SERVICE	B0303026
BULLETIN	2004-01

Subject: Field restraint on Clutch for Broad Area Mower

Models Affected: 968999214,BZ6134D 968999216,BZ7234D, 968999218, BZ6127D, also included 968999221,222,223. All manufactured before 1/15/2004 (040200000)

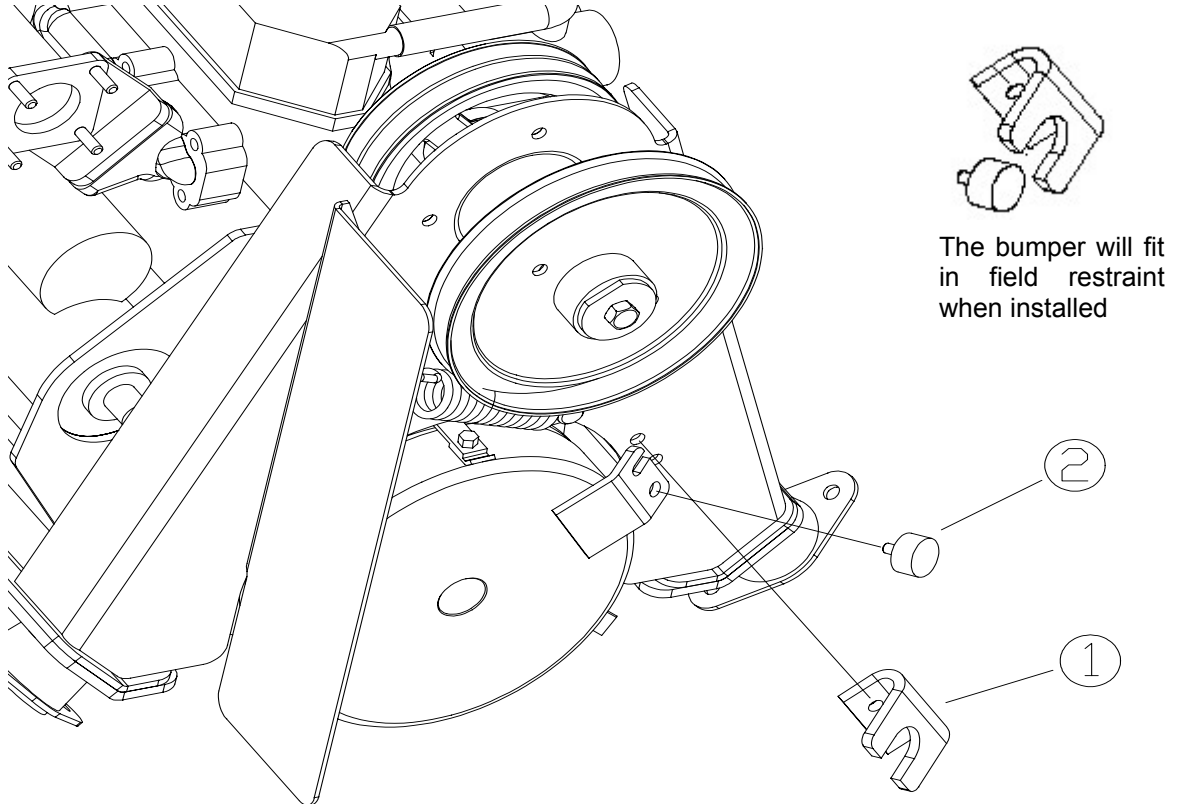
Service Information: The field restraint on the clutch should be replaced when servicing any of the above units. The new restraint uses a rubber isolator to prevent wear between parts. See the following page for details on installation. The new parts are available as a kit, PN 539110654.

1. Remove and discard old restraint. Retain the fasteners for re-use.
2. Using 5/16C Hex Flanged Nut Item 3 (not shown), install Isolator Item 2 in hole in clutch restraint tab as shown.
3. Using fasteners from original restraint, install new Restraint Item 1 in original mounting holes as shown.
Position to straddle isolator item 2 in notch, and install with hex nuts on inside.
